Re: **2 New Hand Pump Wells (PR#74-2024)**
Kingsley Reservoir Campground (PWS ID#95501)
Conditional Approval

Thank you for your submittal to the Oregon Health Authority's Drinking Water Services (DWS) of plan review information for two new wells equipped with hand pumps to serve the *Kingsley Reservoir Campground*, owned and operated by Hood River County.

- SRC-BA Well #2 (Hand Pump Well #1) – HOOD51317 (L150832)**

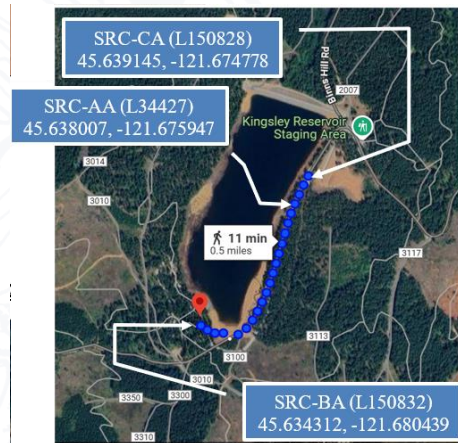
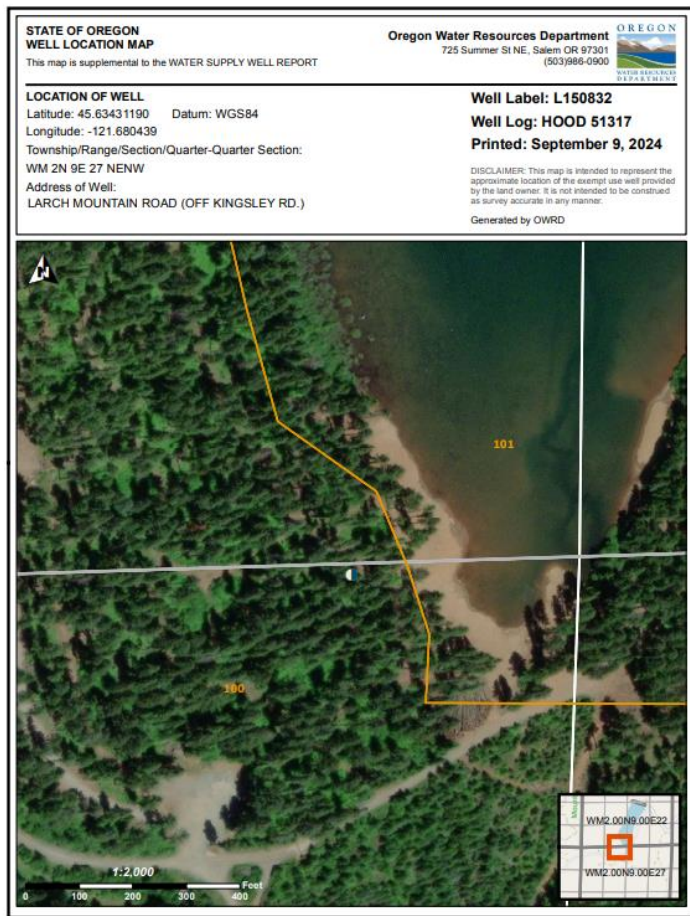
Comments: Calculated 9.1 sacks of bentonite needed for the seal and 15 sacks were used. The well is sealed to a depth of 20 feet below ground surface (ft bgs) into a layer of low permeability (brown clay) that extends from 2 ft bgs to 24 ft bgs. The well construction appears to meet OWRDs Well Construction Standards.

Comments: The area around the well is surficially mapped as Late High Cascades Volcanics (Qvmd). Depth to the water bearing zone was measured at 38 feet below ground surface (ft bgs) and the static water level (SWL) rose to 15 ft bgs. The rise in static water level indicates that the aquifer is most likely confined.

Comments: Source does not meet distance criteria for assessment monitoring at this time. If *E. coli* is confirmed in the source consider for GWUDI.

• **SRC-CA Well #3 (Hand Pump Well #2) – HOOD51318 (L150828)**

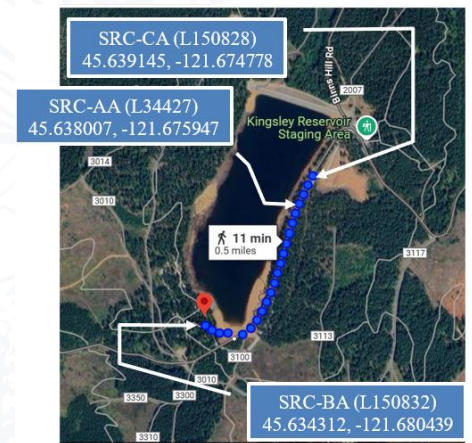
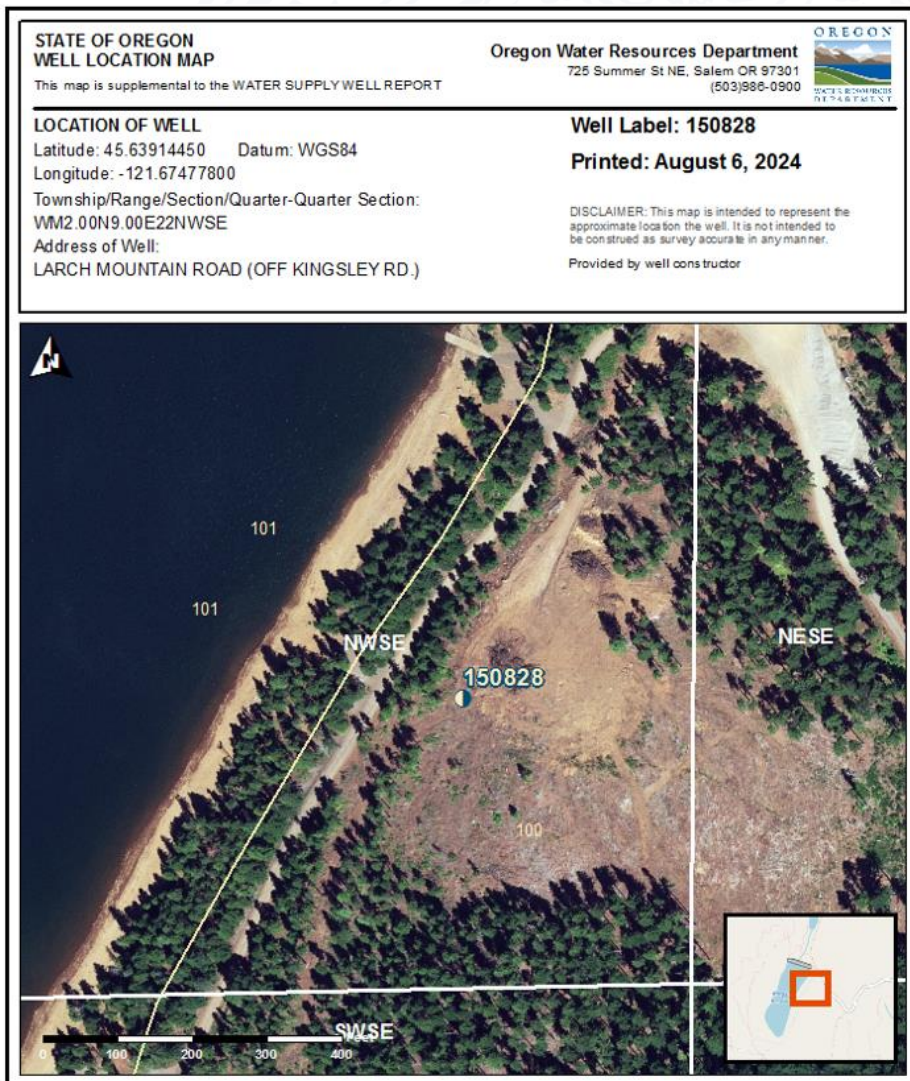
Comments: Calculated 9.1 sacks of bentonite needed for the seal and 15 sacks were used. The well is sealed to a depth of 20 feet below ground surface (ft bgs) into a layer of low permeability (red brown clay) that extends from 2 ft bgs to 26 ft bgs. The well construction appears to meet OWRDs Well Construction Standards.

Comments: The area around the well is surficially mapped as Late High Cascades Volcanics (Qvmd). Depth to the water bearing zone was measured at 56 feet below ground surface (ft bgs) and the static water level (SWL) rose to 18 ft bgs. The rise in static water level indicates that the aquifer is most likely confined.

Comments: Source does not meet distance criteria for assessment monitoring at this time. If *E. coli* is confirmed in the source consider for GWUDI.
